REMARKS

DOCKET NO.: HITACHI-0019

Serial No.: 09/894,017

Response to Office Action dated March 25, 2004

FIG.3

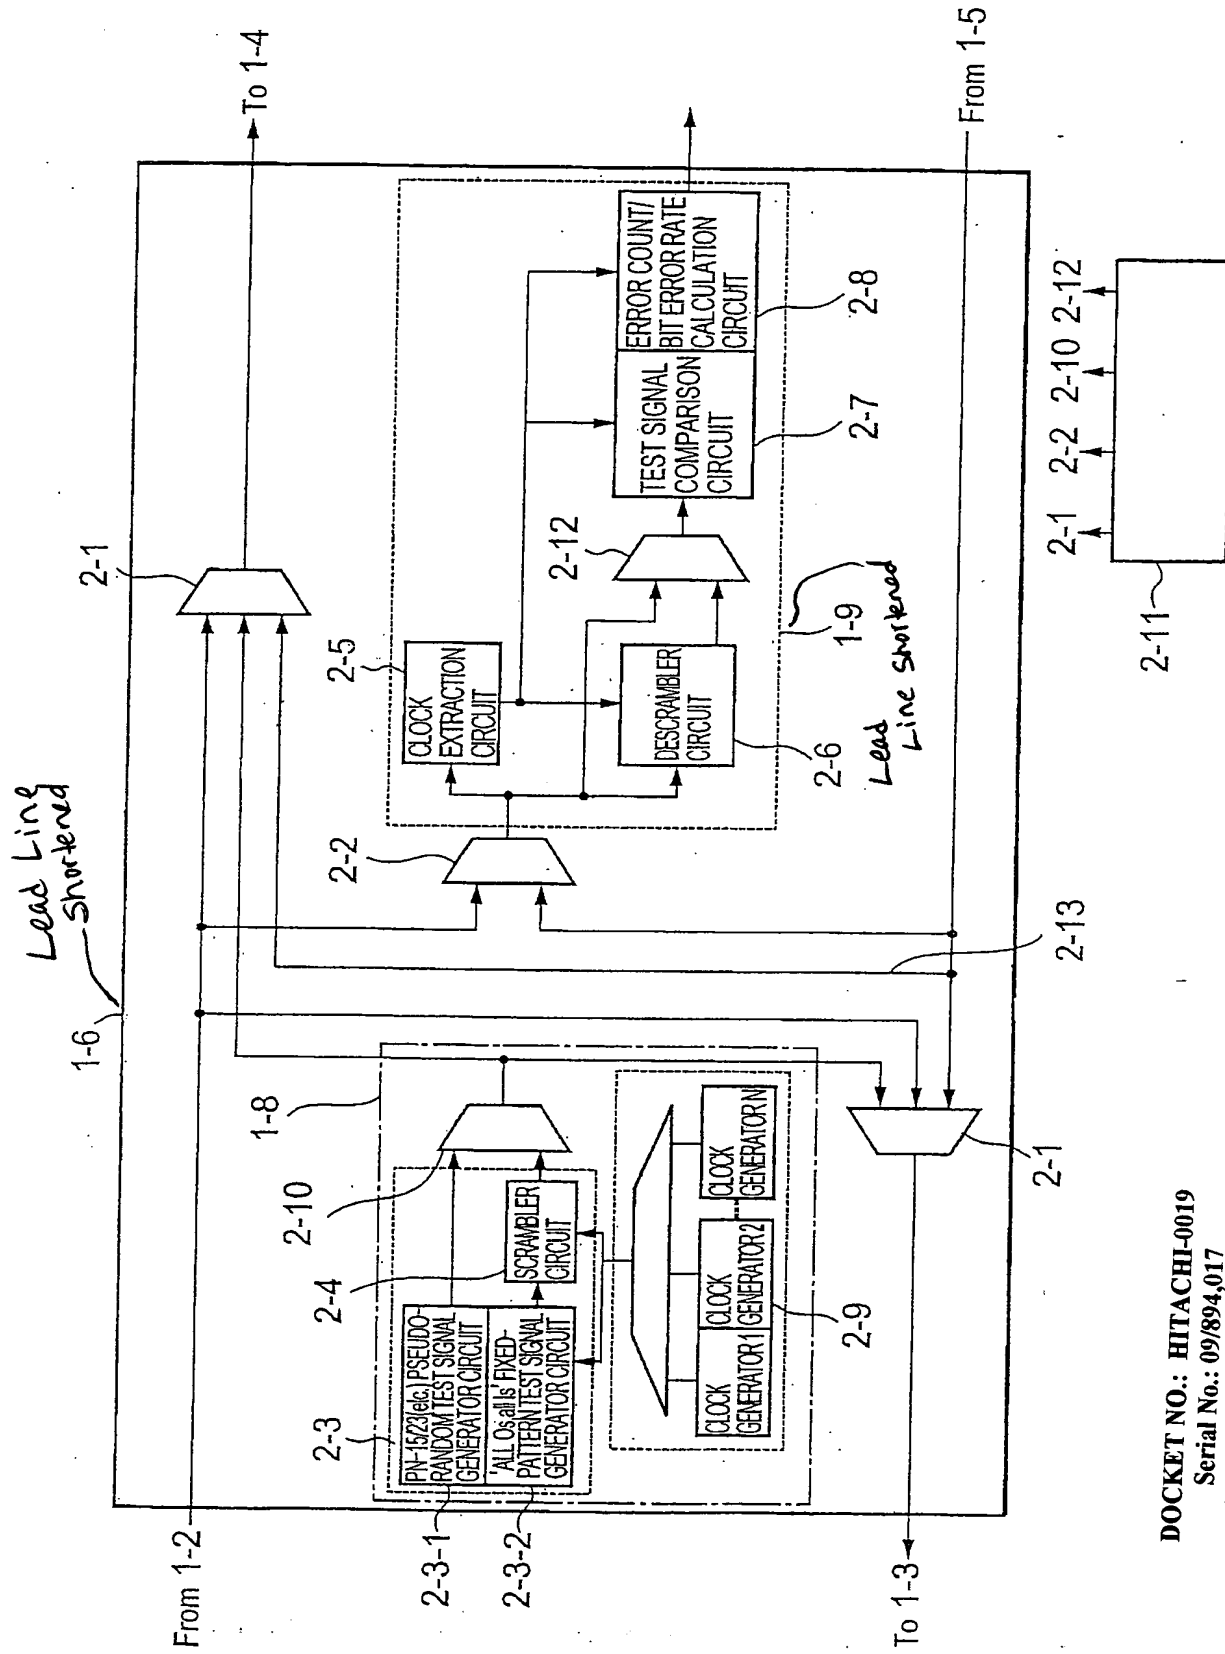
Figures 1, 3, 5, and 6 have been amended to clarify features of the drawings and to correct minor errors in labeling.

Figures 1 and 3 were amended to correct a lead line as to where reference numeral "1-6" and or "1-9" should point. Support for the amendment of Figure 1 can be found on page 7, lines 10-19 of the Applicant's Specification. Support for the amendment of Figure 3 can be found on page 9, lines 4-5 of the Applicant's Specification. Figure 5 was amended to correct a lead line as to where the reference numeral "1-10" pointed. Support for this amendment can be found on page 12, line 15 of the Applicant's Specification. Figure 6 has been amended to correct a mislabeling and to correctly label features of the drawing. Support for these amendments can be found on page 14, lines 13-18 and page 15, line 1 of the Applicant's Specification. No new matter has been added to the Drawings.

FIG.6

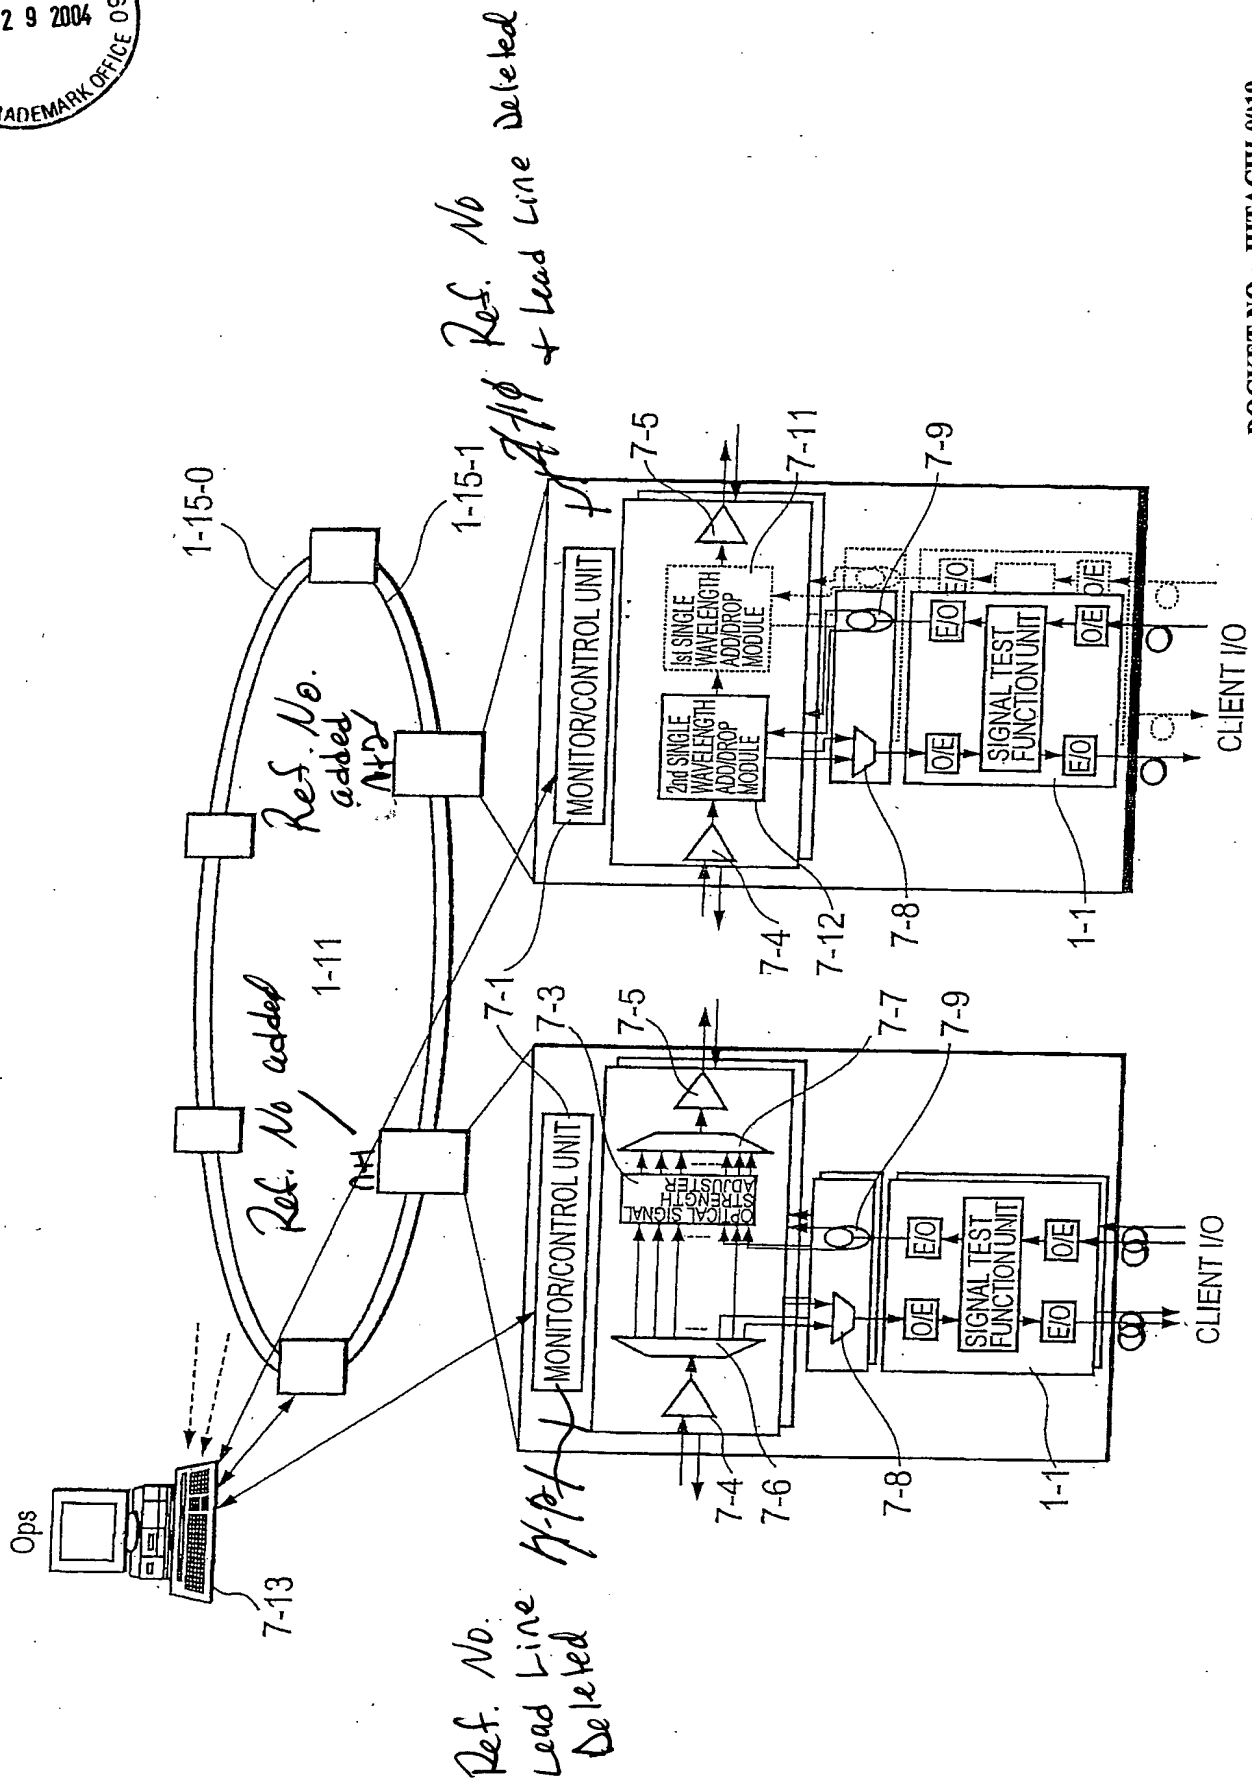
The Examiner rejected claim 21 because, “the applicant does not disclose the claimed optical selector that separates wavelengths.” The Office Action indicates that “the applicant discloses wavelengths being separated by a demultiplexer (fig. 6, element 7-6) or add/drop module (fig. 6, element 7-12) and then sent to an optical selector (fig. 6, element 7-8) that selects between already separated wavelengths.” The Applicant has amended claim 21 by changing the word “selector” to “demultiplexer.” As noted in the Office Action, the demultiplexer separates wavelengths and therefore acts as a optical wavelength separator. The Applicant respectfully submits that newly amended claim 21 overcomes the rejection under 35 U.S.C. §112, First Paragraph and requests that the rejection be removed.
